## REQUEST FOR INFORMATION

| То:   | Royal Construction   | <u>RFI #</u> | 1                |
|-------|----------------------|--------------|------------------|
| Re:   | LVL Penetrations     | Title        | Project Manager  |

| Question(s):  |                                     |                    |  |  |  |
|---|-------------------------------------|--------------------|--|--|--|
| On the first floor at Cannery Trail Residences (The Current), Viking will have two penetrations through B4 – LVL in front of the elevator.      |                                     |                    |  |  |  |

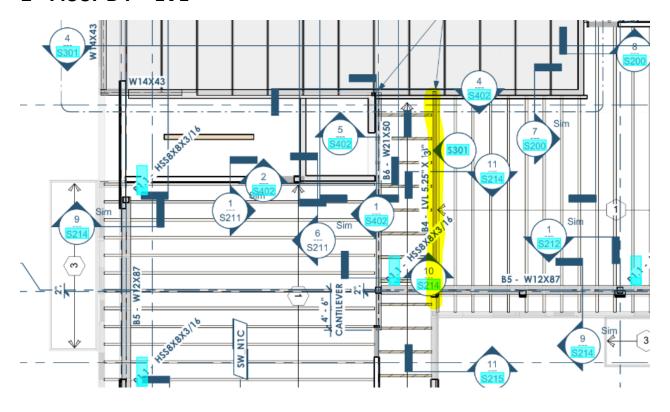
| Question(s):  |                                     |                    |  |  |  |
|---|-------------------------------------|--------------------|--|--|--|
| We will need to core (2) 3" holes through the LVL and are requesting authorization to proceed. The location of the LVL is provided as           |                                     |                    |  |  |  |
| a screenshot in the attachment and can also be found on S211: Framing Plan – 2 <sup>nd</sup> Floor. Also attached is Viking's sprinkler drawing |                                     |                    |  |  |  |
| for that floor with a screenshot of the area being discussed. Please let us know where we can core and what requirements need to be             |                                     |                    |  |  |  |
| followed.   |                                     |                    |  |  |  |

| Question(s):  |                                     |                    |  |  |  |
|---|-------------------------------------|--------------------|--|--|--|
| Holes can be cut at the following locations   |                                     |                    |  |  |  |
|   | 22" 3" 14" 3"                       |                    |  |  |  |
| T + +   |                                     |                    |  |  |  |
